TRANS/WP.29/GRPE/2001/8
20 March 2001

World Forum for Harmonization of Vehicle Regulations (WP.29)

PROPOSAL FOR DRAFT SUPPLEMENT 2
TO THE 01 SERIES OF AMENDMENTS TO REGULATION No. 67

Transmitted by the Expert from the European LPG Association (AEGPL)

9. Examples of current vehicle connectors

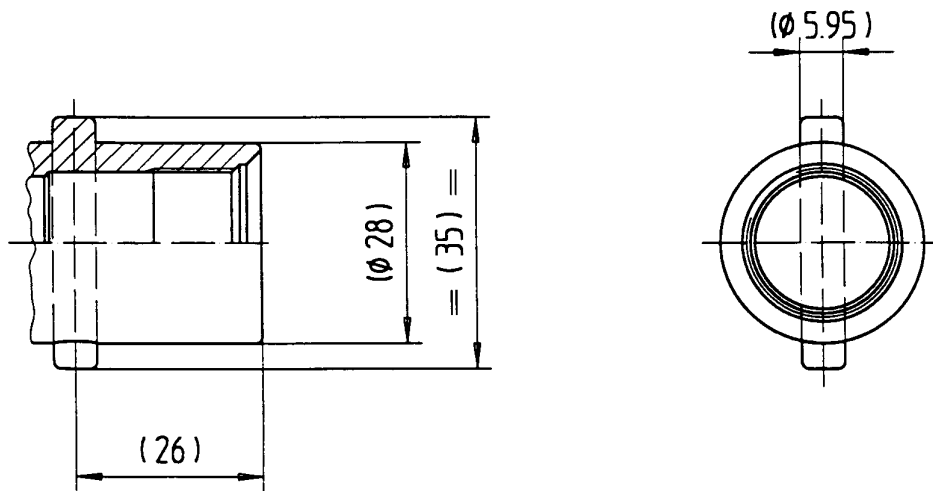
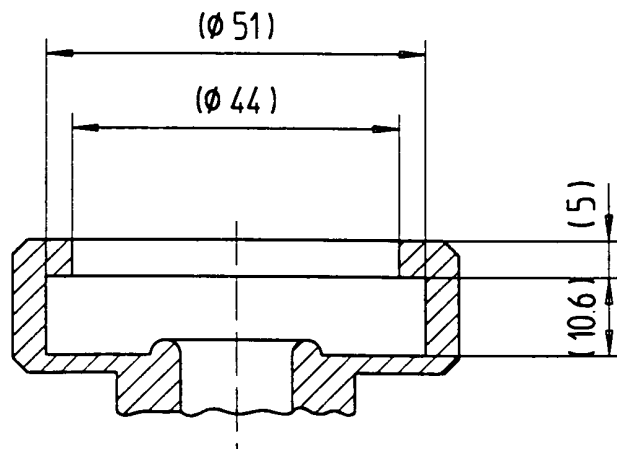
- Note: If during the implementation period of the Euro-connector, the connector body is replaced by a connector body of one of the currently existing types (see the drawings in annex 9, paragraph 9), this connector body does not require a non-return valve.

Note: All the currently existing light vehicle connectors may also be used for vehicles of categories M2, M3, N2, N3 and M1, having a total mass > 3500 kg. */

Figure 4: Light vehicle Euro-connector configuration

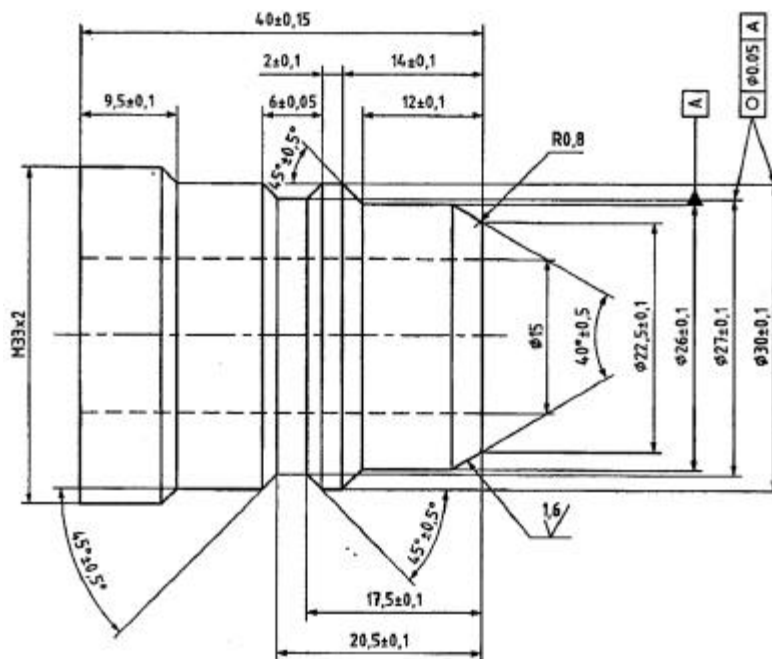
- 6.15.14.6. Specific provisions for the light vehicle Euro-connector:
- (a) The dead volume between the front sealing surface and the front of the non-return valve shall not exceed 0.1 cm³;

30 kPa shall be at least 60 litres/min, if tested with water.

Figure 5: Installation of the light vehicle Euro-connector

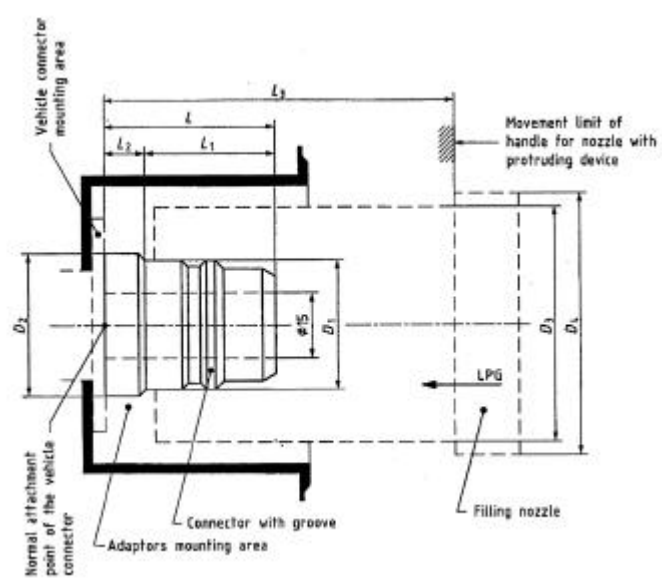
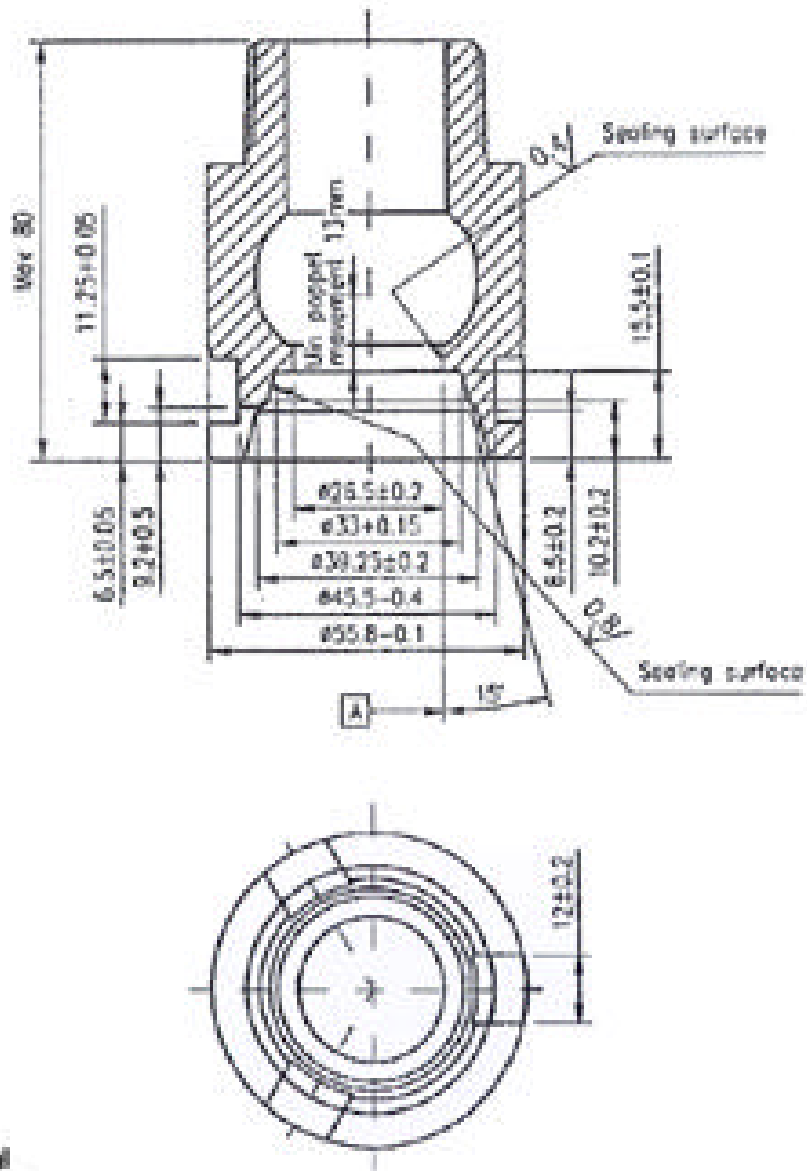
- 6.15.14.5.2. It shall be impossible to remove the connector body from the valve body without specific measures or the use of dedicated tools.
- 6.15.14.5.3. The split between the 2 bodies shall be at the normal fixing point as indicated in annex 9, figure 5.

- 6.15.14.5.4. The length of the connector body of any type, not taking the length of the male thread in account, shall not exceed L in annex 9, figure 5.

Figure 7: Information on the heavy-duty vehicle Euro-connector dimensions

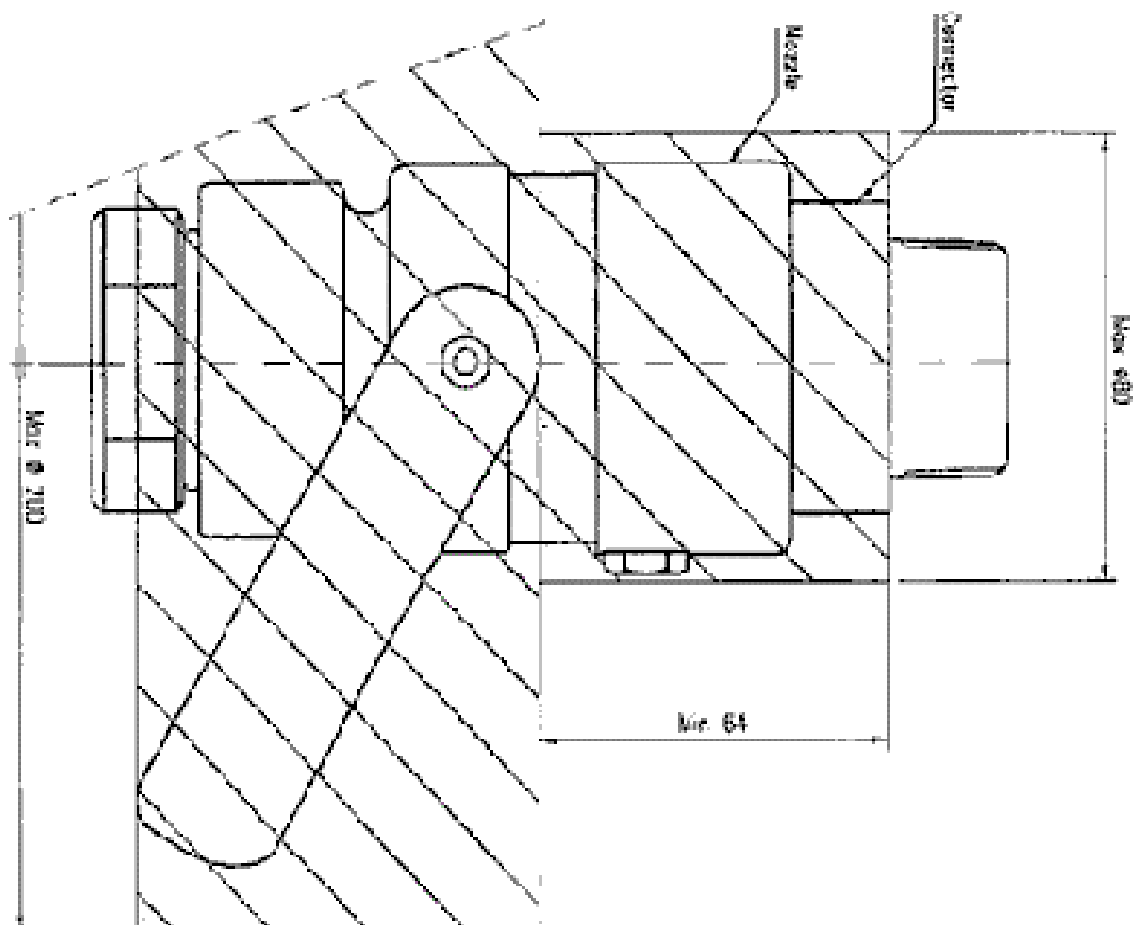
- 6.15.14.7. Specific requirements for the heavy-duty vehicle Euro-connector:
- (a) The dead volume between the front sealing surface and the front of the non-return valve shall not exceed 0.5 cm³;
 - (b) The flow through the connector, with the non-return valve mechanically opened, at a pressure difference of 50 kPa shall be at least 200 litres/min, when tested with water.
- 6.15.14.8. The design and dimensions of the vehicle connector must comply with those in the figures in annex 9.
- 6.15.14.8.1. Examples and critical dimensions of current vehicle connector attachment points and sealing area configurations are shown in annex 9, paragraph 9.
- 6.15.14.8.2. Examples and critical dimensions of the light vehicle and heavy-duty vehicle Euro-connectors are given in annex 9, paragraph 10."
